TECHNICAL BULLETIN

MODEL/DERIVATIVE:
Discovery Series II (LT)

Bulletin N°: 0015
CDS. ref: L8895bu
Issue: 2
Date: 27.01.04

RADIATOR TOP COOLANT HOSE - LEAKING
ACE high-pressure hose chafing radiator top coolant hose.

1

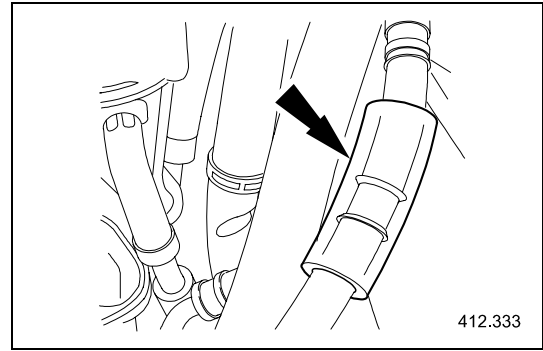
5. If installed, remove the foam protector from the ACE high pressure hose, and discard (see illustration 1).

2

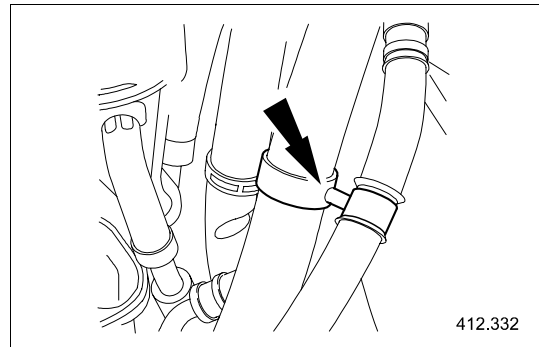
6. If the radiator top coolant hose has abrasion damage, drain the cooling system. Refer to Workshop Manual, part number VDR100090 (8th Edition), Engine Td5 - Cooling System Td5 - Adjustments - drain and refill, repair number 26.10.01.
7. Release and reposition both the radiator top coolant hose securing clips.
8. Remove the radiator top coolant hose from the vehicle remove securing clips and discard the radiator top coolant hose.
9. Install hose securing clips to the new radiator top coolant hose.
10. Install the new radiator top coolant hose to the vehicle; reposition the radiator top coolant hose securing clips.
11. Install the new hose clip spacer (see illustration 2).

Note: Ensure the radiator top coolant hose and the ACE high-pressure hoses are separated.
